# Staff Report

Bourbon County Joint Planning Commission  
Public Hearing: March 15, 2018

**Case Number:** ZMA 18-01 and MS 18-02  
**Applicant:** Brian Rauf  
**Location:** 383 Clintonville Rd.  
**ZMA Request:** Rezoning from R-3 to R-8  
**MS Request:** Preliminary Major Subdivision (MS)  
**Zoning:** R-3 (Residential) in unincorporated County  
**Parcel Size:** 5.7 acres  
**Application Date:** February 19, 2018  
**TRC Meeting Date:** February 26, 20  
**Legal Notification:** March 1, 2018 - Bourbon County Citizen  
**Surveyor/Engineer:** Darnell Engineering, Inc.

## SEWER AND WATER MAP

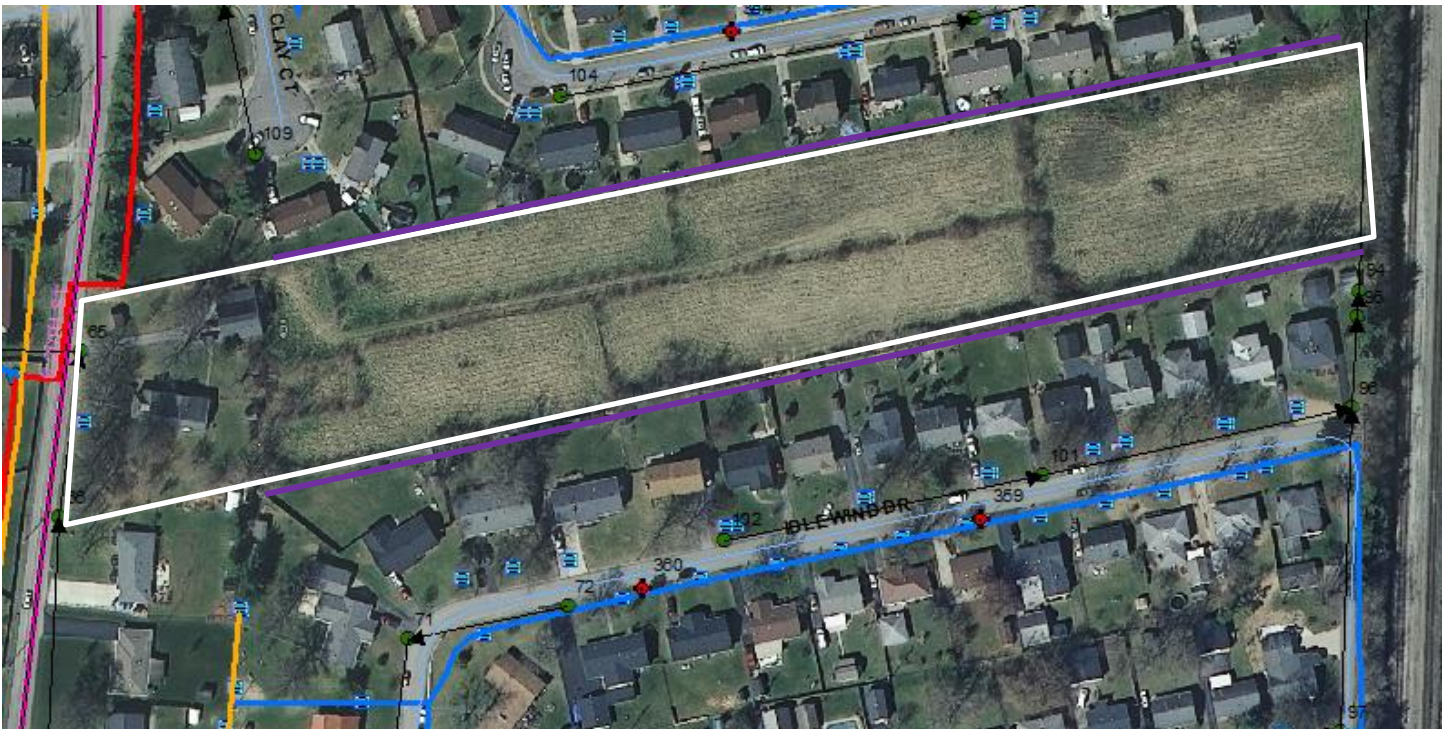
**Sanitary Sewers** – The subject property is serviced by the City of Paris Wastewater Treatment Facility. Sanitary sewer exists in the front and rear of the property.

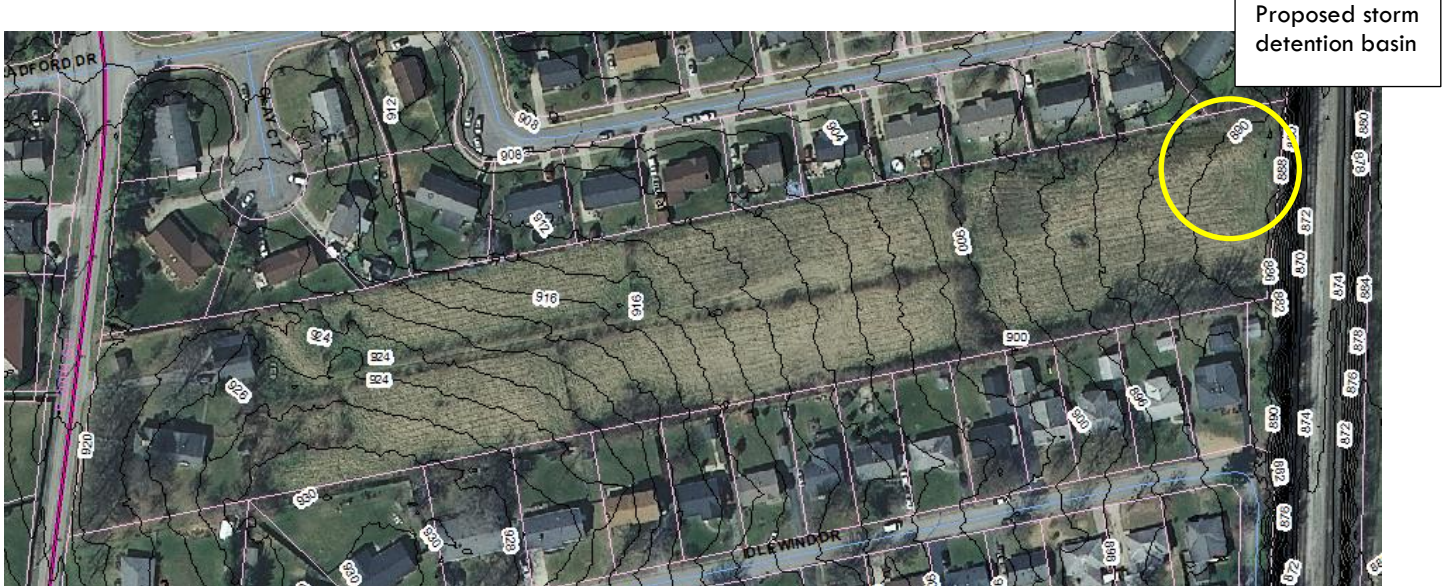
Category	Requirements	Findings
Zoning	If ZMA 18-01 approved, then R-8 Residential. R-8 Residential allows for single-family dwellings, only.	Proposed single-family dwellings. <b>Conforming.</b>
Area, Road Frontage, and Setback	<p>Minimum lot area: 6,300 sf  Minimum lot width at building setback line: 60 ft.  Minimum setback requirements:  Front: 20 ft.  Side: 5 ft.  Rear: 25 ft.</p>	<p><b>Conforming.</b>  ✓ Lot area (range) for new builds: 6,459 sf – 12,128 sf  ✓ Minimum lot width at building setback: 90 ft  ✓ Side Setback: 5 ft.  <b>Variance Requested:</b>  Front setback: Proposed 13.5 ft setback (6.5 ft front setback variance request)  Rear setback: Proposed 23.5 ft setback (1.5 ft rear setback variance request)</p>
Building Characteristics	The City of Paris Zoning Ordinance does not have design standards for new residential developments.	<p>Applicant has provided typical house plans for 1-story ranch style homes on average 1,575 sf.  <b>Required with final development plan:</b>  <input type="checkbox"/> Show building footprints.</p>

Access to Property	Driveways to be shown on plans.	<p><b>Required with final development plan:</b>  <input type="checkbox"/> Show driveway locations on each parcel</p>
Off Street Parking	Single-family dwellings: Two (2) parking spaces for each family unit.	<p>Based on typical house plans provided, each garage would have a 20 ft. setback, leaving a 20 ft. x 21 ft. sized driveway. According to the City of Paris off-street parking standards, the minimum 90 degree parking space is 9 ft. x 19 ft. With the typical house plan provided, each driveway would meet the requirement for two parking spaces.  <b>Required with final development plan:</b>  <input type="checkbox"/> Show driveway capacity to accommodate two (2) vehicles per house.</p>
Streets	<p><b>72.200</b> requires that dead-end streets, design to be so permanently, shall be provided at the closed end with a turn around having an outside radius of at least 40 ft. and a right-of-way radius of at least 50 ft. Such streets shall not be longer than 700 ft., measured from its intersecting right-of-way line to the outer edge of the turn-around, except where conditions make this limitation impracticable.  <b>72.210</b> To the extent possible, block lengths shall not exceed 1,600 ft. or be less than 500 ft.  <b>72.203</b> Street right-of-way (ROW) and pavement widths shall not be less than the following: ROW 50 ft., pavement width 26 ft.</p>	<p>Conforming.  ✓ Radius of roundabout and cul-de-sac meets the minimum radius requirements. Proposed is 40 ft. radius and 50 ft. outside radius.  ✓ Proposed pavement width is 26 ft. and ROW 50 ft.  <b>Waiver Requested:</b> Applicant requests a waiver of the 700 ft. maximum length requirement. In attempt to calm traffic, a roundabout is proposed at 700 ft.</p>

Category	Requirements	Findings
Traffic Volume (Trips per day)	Anticipated trip generation required. "Driveway Trips" mean the total number of trips that are generated by a site.	Per the Trip Generation manual of the Institute of Transportation Engineers, the vehicle trip rate for a per dwelling unit is 9.6 trips per day. Estimated trip generation for 23 houses is 221 trips daily. <b>Required with final plan:</b> <input type="checkbox"/> Obtain approval for entrance and abide by any necessary upgrades from Kentucky Transportation Cabinet District 7.
Utilities	72.216 Wherever practicable, telephone and electric service lines shall be placed at the rear of all lots or underground, and all transformer boxes shall be located so as not to be unsightly or hazardous to the public.	<b>Staff Comments:</b> Current electric utilities provided by KU are located on the adjacent properties (see aerial photo on page 2). Upon consideration of the requested setback variances, staff recommends the Commission require a condition that the applicant install underground utilities.

Sewage	72.305 Where an approved sanitary sewer is accessible to the development, all necessary mains and laterals for connection from lots to the system, as shown on the preliminary plat shall be installed by the subdivider.  72.410 When a connection of public water or sewer facilities is proposed, assurance of the availability of the service must be presented to the Planning Commission before approval of the final plan.	<b>Staff Comments:</b> Existing gravity flow sewer lines are located at the front and rear of the subject property.  <b>Required with final plan:</b> Assurance/certification of water and sewer service must be presented to the Planning Commission before approval of the final plan.
Drainage	Stormwater Plan, including location of catch basins, manholes, retention/detention basins, calculations.  City of Paris Title 4: Traffic Regulations, Chapter 41: Streets, Sidewalks, and Other Public Places.  41.206 – Stormwater handling facilities (inlet basins, culverts, pipe, retention areas, etc.) shall be designed such that stormwater drainage from the proposed construction to adjacent properties shall not exceed the pre-development stormwater discharge rate. The finished construction shall not create any adverse effect (erosion, flooding) on adjoining property owners.	Based on preliminary calculations, applicant has identified and area for proposed storm detention basin (see topography map on page 4).  <b>Required with final development plan:</b> Submit stormwater plan, including location of catch basins, manholes, retention/detention basins, and calculations.  <b>Staff Comments:</b> Detention area is proposed near an existing sewer line in the rear of the property. As the applicant further explores placement, be sure the detention pond will not encroach on the sewer line.

Landscaping	72.215: Wherever possible, the subdivider shall preserve trees, groves, waterways... 72.309: Wherever the site is not naturally wooded, the subdivider may be required to plant street trees...	<b>Staff Comments:</b> Suggest applicant consider preserving some of the larger trees at the front of the property near Clintonville Rd. Suggest planting of small to medium street trees.

Category	Requirements	Findings
Sidewalks	<p>City of Paris Title 4: Traffic Regulations, Chapter 41: Streets, Sidewalks, and Other Public Places.</p> <p>41.205: In residential subdivisions, sidewalks are required on both sides of the street, the full length of the streets. Sidewalks shall be a minimum of four feet (4') wide and four inches (4") thick ...</p>	<p><b>Conforming.</b>  Comments: See "Typical Cross Section" on Subdivision Plat. This shows a proposed 4 ft. wide sidewalk.</p>
Certifications	<p>72.175: General requirements to be considered for final plat approval are provision for water, sewage, and other utility services, provision for schools, and provisions for essential municipal services.</p>	<p><b>Required with final plan:</b>  Assurance/certification of water, sewer, fire, and school must be presented to the Planning Commission before approval of the final plan.</p>

- Approval of the waiver request for the 700 ft. street length maximum requirement due to the long and narrow shape of this property and inability to connect with developments to the north and south. These make the road length maximum impractical. To mitigate this issue, the applicant has added traffic calming measures by use of a roundabout at approximately 700 ft. into the development. However, staff recommends the following conditions:

- Applicant install mountable aprons\* at center of roundabout and cul-de-sac for use by vehicles with a wide and/or long wheelbase.
  - Applicant establish "no parking zones" on perimeter of roundabout and along one side of the street, ideally the side that contains fire hydrants.

- Approval of the front setback variance request of 6.5 ft. and rear setback variance request of 1.5 ft. However, as a condition of this approval, staff recommends the following conditions:

- Applicant install privacy fencing along the rear of each property.
  - Applicant install underground utilities.
